Commission of Architectural Review

**MARCH 24, 2022
3:30 P.M.
FOURTH FLOOR CONFERENCE ROOM**

RE: **CERTIFICATE OF APPROPRIATENESS REQUEST – 820 PINE STREET**

Certificate of Appropriateness Request PZ22-31, to remodel an existing building including front porch reconstruction, demolish rear of structure, install new wood windows, and build a rear covered porch at 820 Pine Street (Parcel ID#23604). Bringing the house back to its 1899 footprint will enhance the historically significant building elements

A1.2

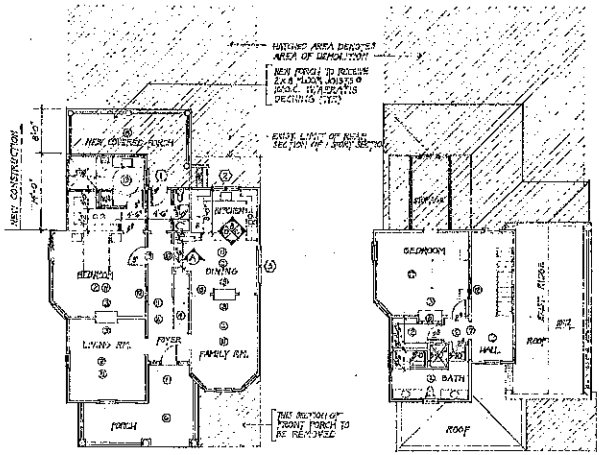
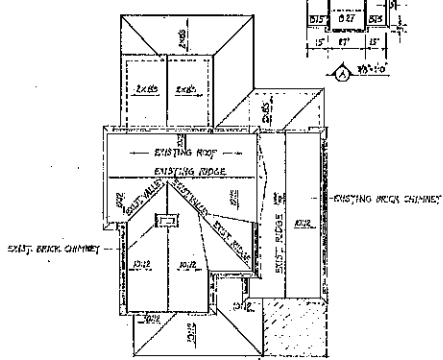
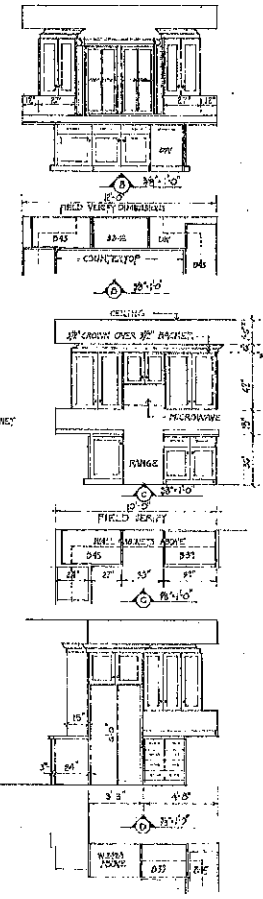
3. **Rear Addition Demolition.** This component of the remodeling plan also restores the main building to its 1899 footprint matching the Sanborn Map.

Demolishing the rear additions of 820 Pine Street implements the Guidelines because it recreates the authentic building footprint in accordance with Guidelines' Section 3.C.3.

5. New rear covered porch The remodel includes a rear covered porch at 820 Pine Street per the submitted drawings.

The new covered porch is inset from the rear building corners on a secondary building elevation; reflects the materials, scale, and proportions of the building; and the details and finishes will complement the historic building character. The 8’ covered rear porch with standing seam metal roof and ramp conforms to the OWE Design Guidelines in 5.C.1. and 5.D.2. “porches are an almost universal feature of residential architecture.”

Staff recommends the Commission of Architectural Review approve Certificate of Appropriateness PZ22-31 as presented.

NORTH ELEVATION

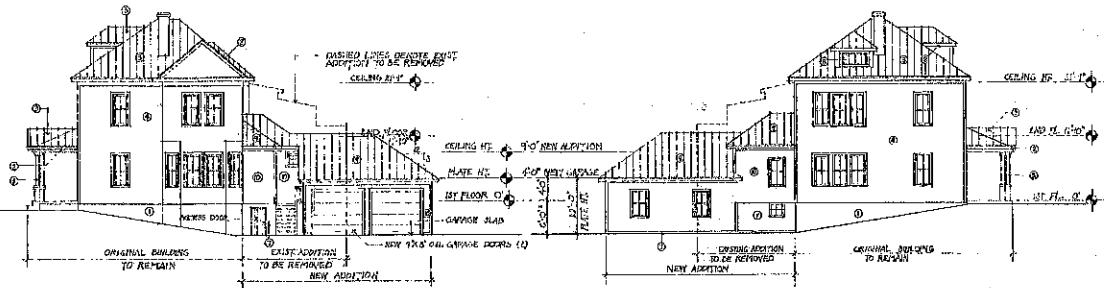
1. Front Porch. The remodel will rebuild the existing front porch and add period appropriate support columns while reusing existing materials as possible on the primary building elevation. Substitute materials are required because although the plinths remain, the original columns are gone. Guidance from [Preservation Brief 45 - Preserving Historic Wood Porches](#) directs the applicant to "select those (replacement materials) that can be painted or stained in the field."

2. Siding. The remodel plan will expose the original wood siding by removing the existing aluminum siding. Rotted areas will be replaced with matching profile wood siding. If more than 50% of the siding on any exterior wall area is damaged beyond repair, then the applicant should replace the siding with a matching profile, non-vinyl siding may be installed in conformance with OWE Guidelines.

4. **Rear Addition Demolition.** This component of the remodeling plan removes a dilapidated rear building addition.

Motion to approve COA request PZ22-32 at 844 Pine Street because the remodeling plan for restoring the front porch will include paintable columns, remove aluminum siding plus restoring wood siding and trim, add a new window with historic window material to the second story front primary building elevation, repair all wood windows on the primary elevation or replace them with historic window materials, restore historic window materials or replacing windows on all secondary elevations with modern windows, demolish the rear addition, and build a new rear addition including a 2-car garage meets The Guidelines for Property Improvement, with the following conditions:
